## VILLA D'ESTE JSP17-52 with Rezoning 18.718

Public hearing at the request of Cambridge of Novi, LLC for Planning Commission's Recommendation to City Council for a Planned Rezoning Overlay Concept Plan associated with a Zoning Map amendment, to rezone from RA (Residential Acreage) to R-1 (One-Family Residential). The subject property is approximately 51 acres and is located east of Napier Road and on the north side of Nine Mile Road (Section 29, 30). The applicant is proposing a 56-unit single-family housing development (for sale).

## PLANNING REVIEW

**SHEET 2**

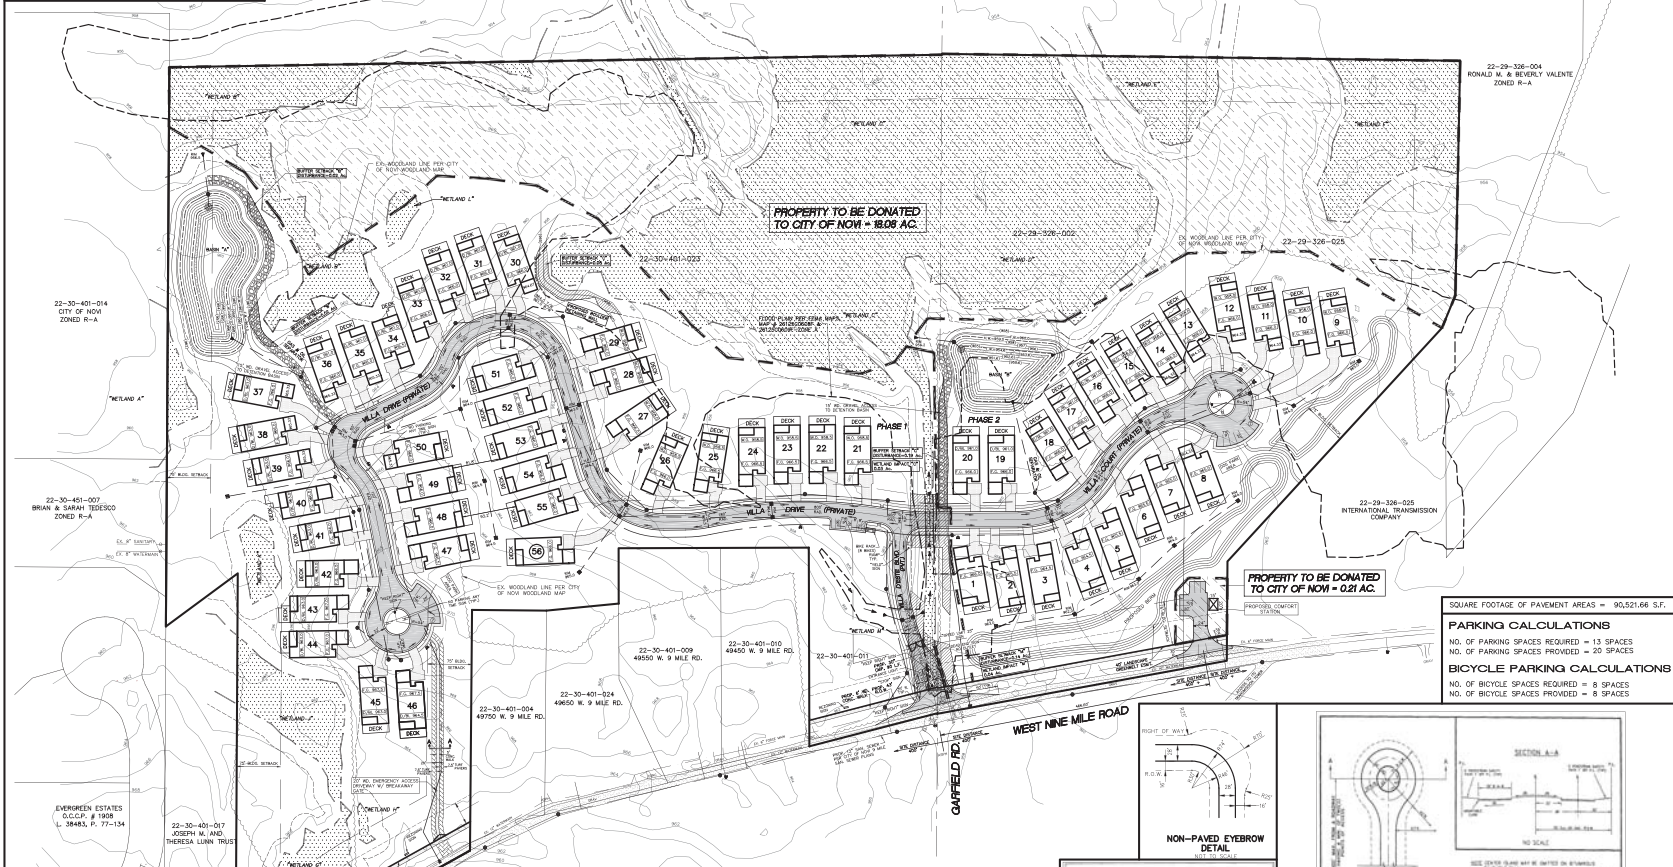
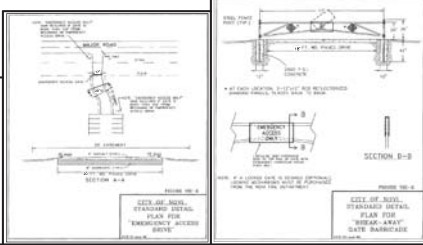
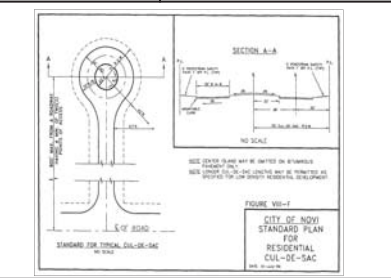
- i. The proposed unit boundary shown on the concept plan (sheet 02) is to be considered the maximum allowable footprint. Any accessory uses such as hot tubs, patios, etc. will be provided within the footprint shown on the plan.

- a. The development shall be limited to a maximum density, to be determined at the Planning Commission meeting of 56 units.
    - b. The proposed unit boundary shown on the concept plan (sheet 02) is to be considered the maximum allowable footprint. Any accessory uses such as hot tubs, patios, etc. will be provided within the footprint shown on the plan.

2. The proposed unit boundary shown on the concept plan (sheet 02) is to be considered the maximum allowable footprint. Any accessory uses such as hot tubs, patios, etc. will be provided within the footprint shown on the plan.
3. A minimum of 15 feet shall be maintained between two buildings.
4. A minimum of 30 feet is provided between the front façade and the back of the curb.
5. The applicant will work with staff to identify a proper location to connect to ITC trail, beyond the subject property line.
6. The applicant shall limit the wetland and woodland impacts to the areas and percentages indicated on the concept plan at the time of Preliminary Site Plan.

1. The proposed unit boundary shown on the concept plan (sheet 02) is to be considered the maximum allowable footprint. Any accessory uses such as hot tubs, patios, etc. will be provided within the footprint shown on the plan.
2. A minimum of 15 feet shall be maintained between two buildings.
3. A minimum of 30 feet is provided between the front façade and the back of the curb.

- See sheet 2 for density calculations; overall site density = 1.10 units/acre < 1.65 max (R-1)
- As requested, conceptual lot lines have been shown on the Lot Detail on sheet 2.. If required for implementation of the site plan as proposed, **a deviation is requested for all units as one deviation due to the form of development compared to typical lots. The development pattern and condominium documents are to be considered as one deviation in whole.**

- Front, Rear & Side Setbacks; Lot Coverage: As requested, conceptual lot lines have been shown on the Lot Detail on sheet 2 to assist in specifying deviations required. If required for implementation of the site plan as proposed, **a deviation is requested. See response above.**
- Gated Community: City Council approval will be requested for this item.
- % of lot coverage cannot be provided as there are no lots. **A deviation is requested.**

- Each unit will accommodate 2 parking spaces in the garage and 2 spaces in the driveway between the unit and the sidewalk
- 20 visitor parking spaces are provided and shown on sheet 2, which meets requirements so a deviation is not required. In addition, on-street parking will be allowed except where there are site distance constraints. (e.g. on the inside curve between units 48 – 53).
- Snow stockpiling locations have been provided and shown on the landscape plan sheets.
- Bicycle Parking is provided and shown on sheet 2, also per requirements. A total of 8 bicycle spaces are provided..
